Grande Allée and Forecourt Parks - Old Ottawa East

Attachment 1: OOE Grande Allée Proposed Additional Trees, Crossing of Deschâtelets Avenue and Fire-Lane

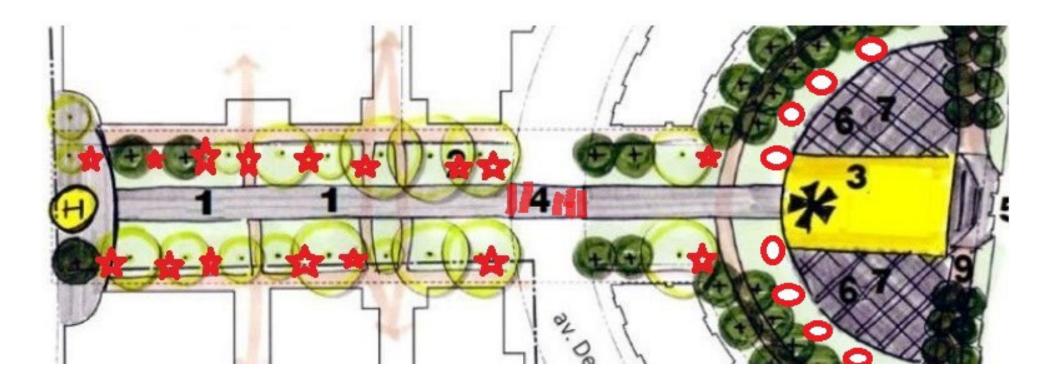
1. Additional Trees: The Old Ottawa East Community Association requests that the City of Ottawa plant additional trees in the new Grande Allée Park within the Greystone Village neighbourhood of Old Ottawa East. Specifically, we urge the City to plant additional trees between and to the west of the new trees that were added during the course of the creation of the Grande Allée Park and between other trees along the Allée where these other trees are in poor health. See Attachment 1.

Our objective here is to ensure that the Allée is lined and well-shaded by two rows of thriving trees so that when failing trees are removed there will be succession trees of substantial size. We appreciate that the design of the new park reflects the desire to have stall areas for the Main Farmers' Market but we do not foresee that additional trees will in any way constrain the functioning of the market.

3. **Safe Pedestrian/Cyclist Crossing of Deschâtelets Avenue:** As additional planning is required for Regional's "Greystone Forecourt," the new school / community centre / seniors housing, and the actual Forecourt Park, we would like to ensure that there is a well-designed crossing of

Deschâtelets Avenue so that pedestrians and cyclists may safely travel along the Grande Allée corridor and into the Forecourt Park and on to the river multi-use pathway. The planning of this crossing must not be an "after-thought." It needs attention now.

- 4. *Fire-lane in Front of Deschâtelets Building:* Originally, there was to have been a narrow, soft-surfaced and very limited access road in front of Deschâtelets Building with its primary purpose being for emergency vehicles. We subsequently have heard that this will now be a paved route used by school buses as well as emergency vehicles. We would like to be consulted on the evolving City-school board discussions on the design of this roadway. We are of the view that there must be severe limitations of motorized vehicle use of this roadway because of its proximity to the Forecourt Park and its interrupting the pedestrian and cyclist traffic flow.
- 5. **Planning of Forecourt Park:** We would appreciate being regularly brought up to date on the planning of the Forecourt Park and be consulted when there is an issue that the community is interested in.
